**CERTIFICATE OF APPROPRIATENESS**

**Applicant:** Sarah Hannah, agent for Melissa B. Hagan, owner

**Property:** 212 Bayland St, Tracts 14A & 15A, Block 3. Woodland Heights Subdivision. The property includes a two-story wood frame approximately 2,905 square foot single-family residence situated on a 6,500 sq. ft. corner lot.

**Proposal:** Alteration- Addition, Doors, Windows

# Historic Window Standard: New Construction & Replacement

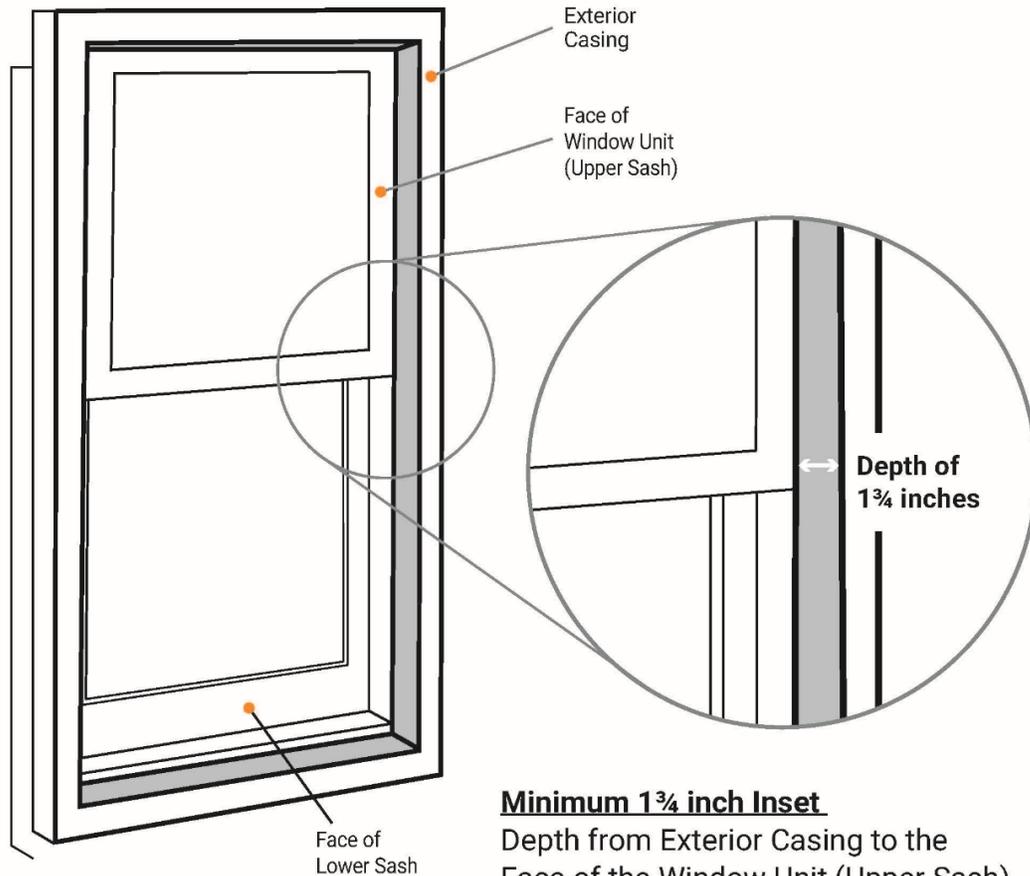
## **Minimum 1 3/4 inch Inset**

Depth from Exterior Casing to the Face of the Window Unit (Upper Sash)

Windows must be 1-over-1  
(equally horizontally divided)

1 3/4 inch minimum inset for Fixed Window

**ALL NEW WINDOWS MUST BE INSET 1¼ Inches – See Attachment 1**

**1-over-1 Windows Must Be Equally Horizontally Divided**
